Alder Lake-S OEM & ODM CRD Survey Report (Desktop Segment)

ACER, AS ROCK, ASUS, DELL, LENOVO, MSI, LITEON, FOXCONN, LCFC, ECS
2020 - WW45 Rev 0

Stencil Design Recommendation – Socket V0 (LGA1700-0) Center Volume Paste

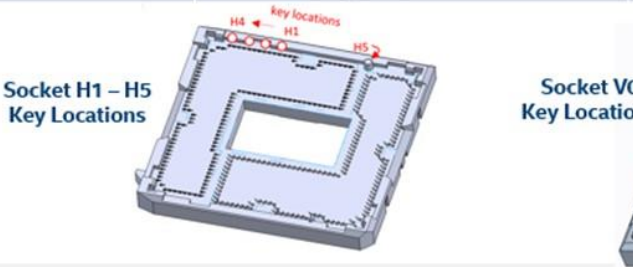
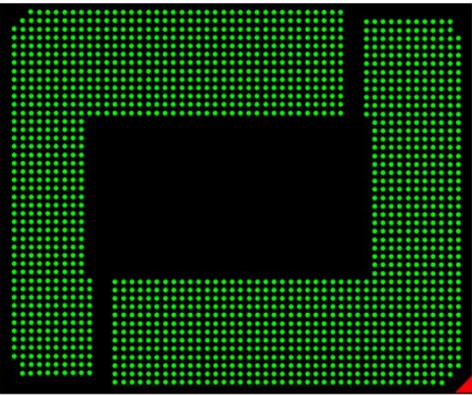
- SJQ concerns for potential insufficient total solder volume (~10% lesser?) in solder joint formation. LOTES (0.45mm ball size) vs FIT/Deren (0.5mm ball size) but MAS recommended the same solder paste volume.

LOTES solder ball size is smaller than Deren & FIT, customer's concerns with SJQ with the same paste volume recommended in MAS across all socket supplier.

- This aperture size shown here may not be optimized for all socket suppliers.
- Intel is currently investigating a larger aperture size stencil to mitigate any HnP or Opens risk, in the Air Reflow Environment

Socket-V

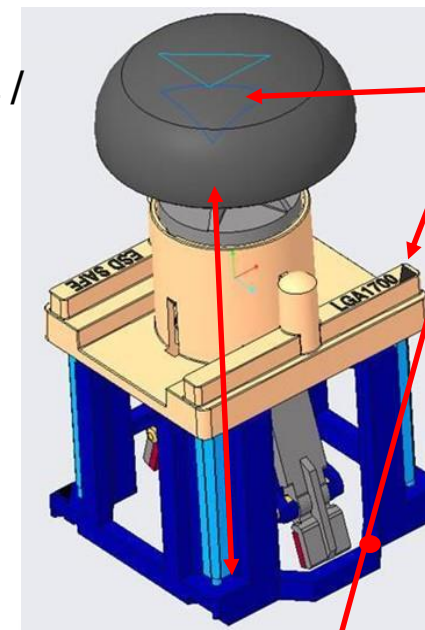
This site facing operator
(it will be inconvenient for same operator to process
skt-H and skt-V, and possibly error in execution, due
to the need to rotate the processor 180° orientation)

Pin 1, diagonally
opposite compare to
skt-H & also PnP tool /
stage

Which Pin 1
label is
correct ?

The Pin 1 mark
on tools are
inconsistent to
Pin 1 indicator
on PCB

- 1) Operator needs to rotate processor 180° from PnP tool/stage in order to align to PCB Pin 1.
- 2) Any possibility to make changes for socket-V the ILM to allow customer process transparency and mitigate execution error for manual process ?eg. 180° marking orientation change on ILM cover marking

Manual Assembly risk

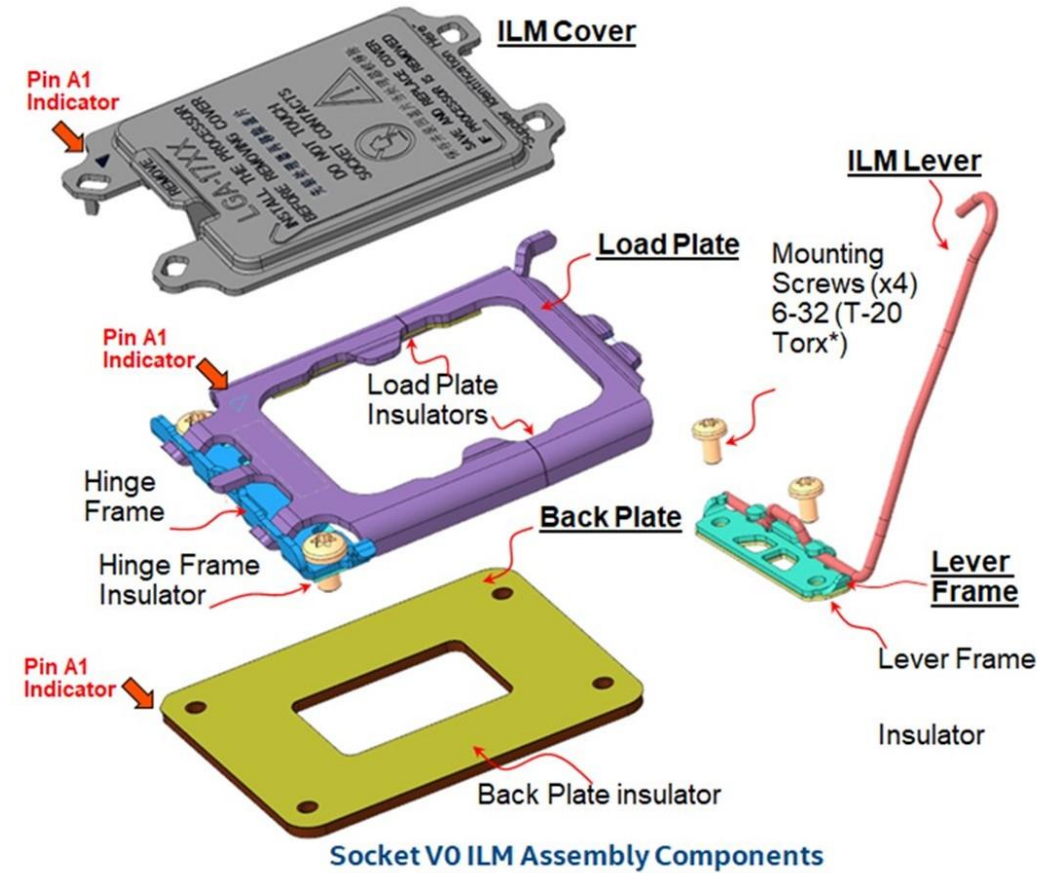
- 1) PCB Top Side> Potential/risk for operator swapped lever frame and load plate locations during assembly.
- 2) Backplate> Potentially 180° orientation assembled.

6.7.6 Contact Failure Type 3: Y-Axis Shift

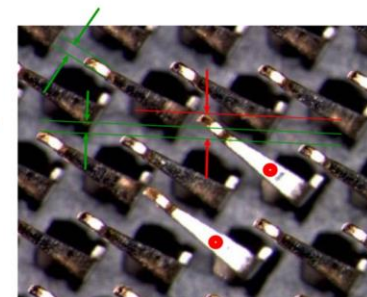
Intel FAE	Socket bend pin pass/fail criteria in MAS > Need to re-assess the type 3 x-y axis shift visual criteria for ± 0.125 mm, due to tighter pitch in skt-V (0.8mm) vs skt-H pitch 0.914mm. Is the contact pin always making contact to the LGA pad center ? Will the contact pin that passing 0.125mm still passing electrical test ? as the pin may be touching/ too close to the adjacent CPU LGA.

Tighter pitch but more relax criteria ?

- original >1 width vs current >1.5 width

Is the pin contact always contacted at the center of the LGA pad or near pad edge ? with the process variation and X-Y shift, will the pin be touching LGA Au pad or outside the Au pad (Solder resist area) or adjacent Au pad ? -- Need Intel design to assess
